**CITY OF AVON LAKE
PLANNING COMMISSION
150 Avon Belden Road
Avon Lake, Ohio 44012
(440) 930-4110**

**AGENDA
Tuesday, November 4, 2025
7:00 PM
City Council Chambers**

HARBOR CREST TOWNHOUSE SUBDIVISION NO. 1 - IMPROVEMENT PLAN

Re: Case No. CPC-25-17, Pulte Homes of Ohio, LLC, Major Subdivision, Improvement Plan for Harbor Crest Townhouse Subdivision No. 1 located at the southeast corner of Walker Road and Avon-Belden Road (State Route 83).

**HARBOR CREST
TOWNHOUSE SUBD. NO. 1
GRADING PLAN**

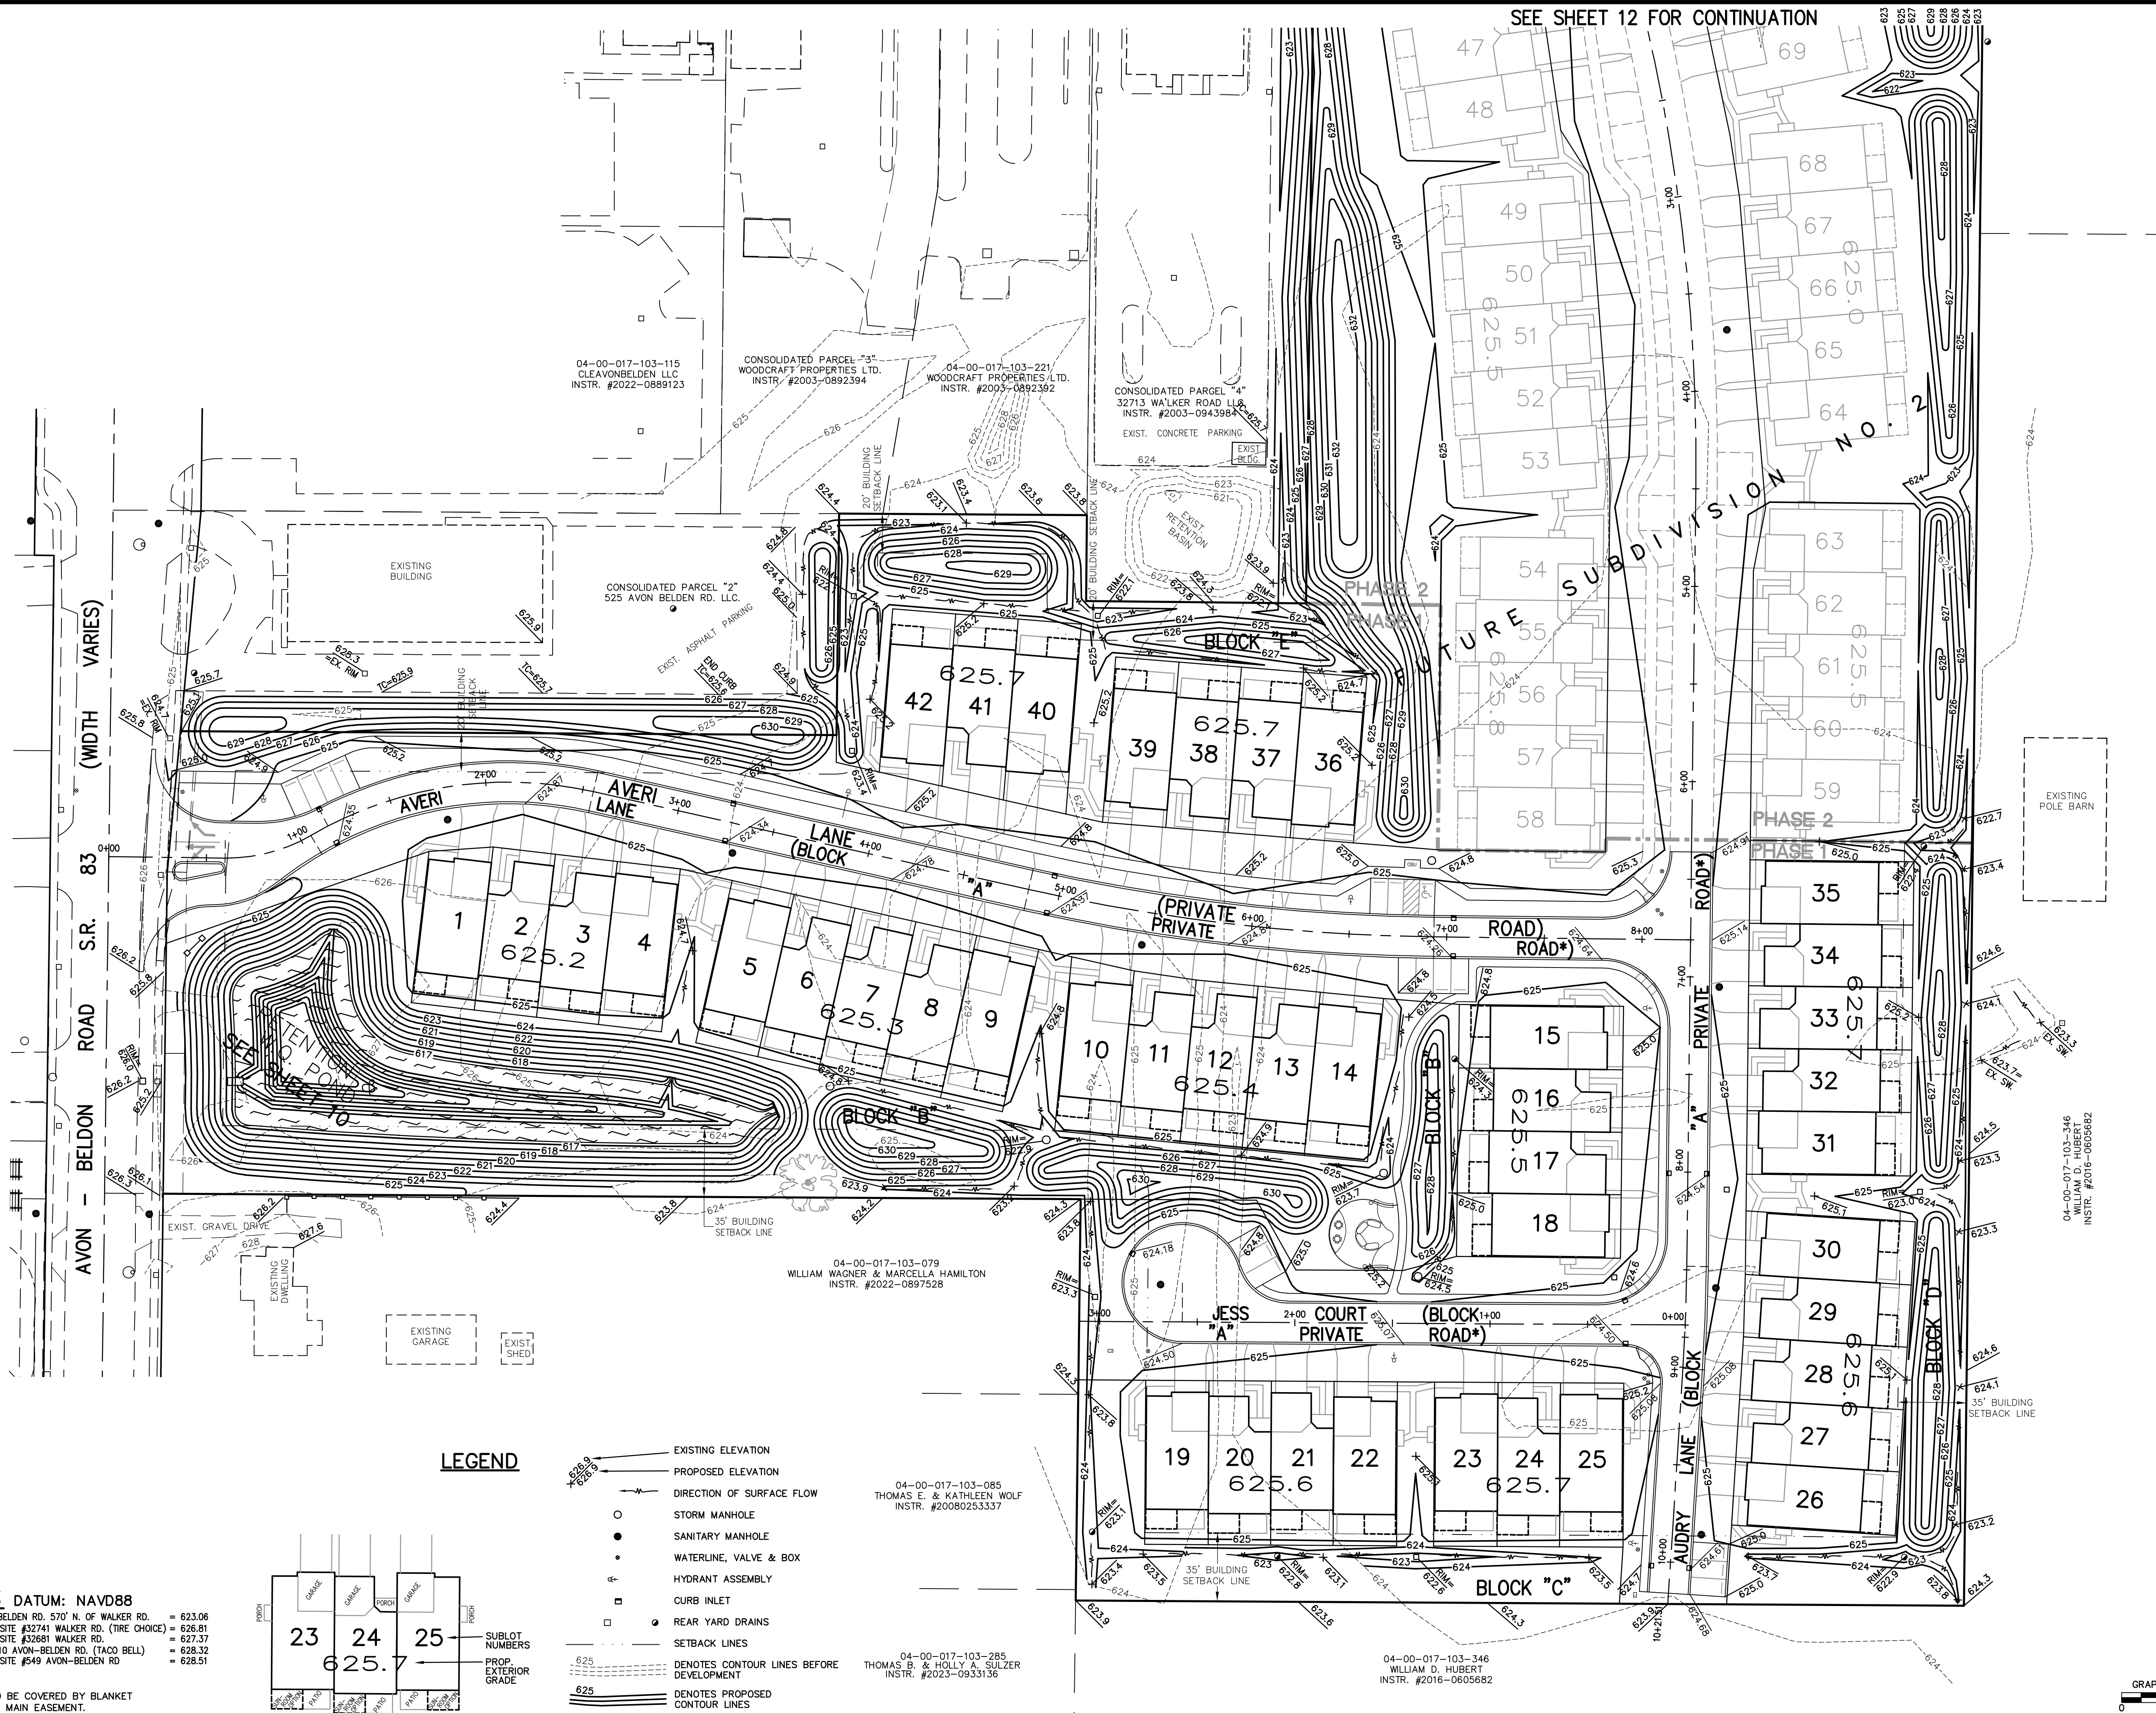
1. Add a note that all blocks are to be owned and maintained by HOA. 2. Add another note that the entrance/exit island to be maintained by HOA. 3. Please provide a plan depicting landscaping/buffering. Buffering is required where the property abuts single-family residential. Also depict any fencing throughout the development. 4. Depict/label proposed entrance signage.

1. A note was added to the lower left side of sheet 2 that indicates all common blocks are to be owned and maintained by the H.O.A.
2. A note was added to the lower left side of sheet 2 that indicates that the landscaped island at the entry is to be maintained by the H.O.A.
3. A landscape plan will be delivered to the City under separate cover.
4. The entrance sign depicted on sheet 2 was labeled and its details will be provided in the landscaping plan provided under separate cover.

REVISIONS	
REVISED PER ZONING DEPT. COMMENTS & MOVED MOUND INTO ADJ. EASEMENT	
10/29/25
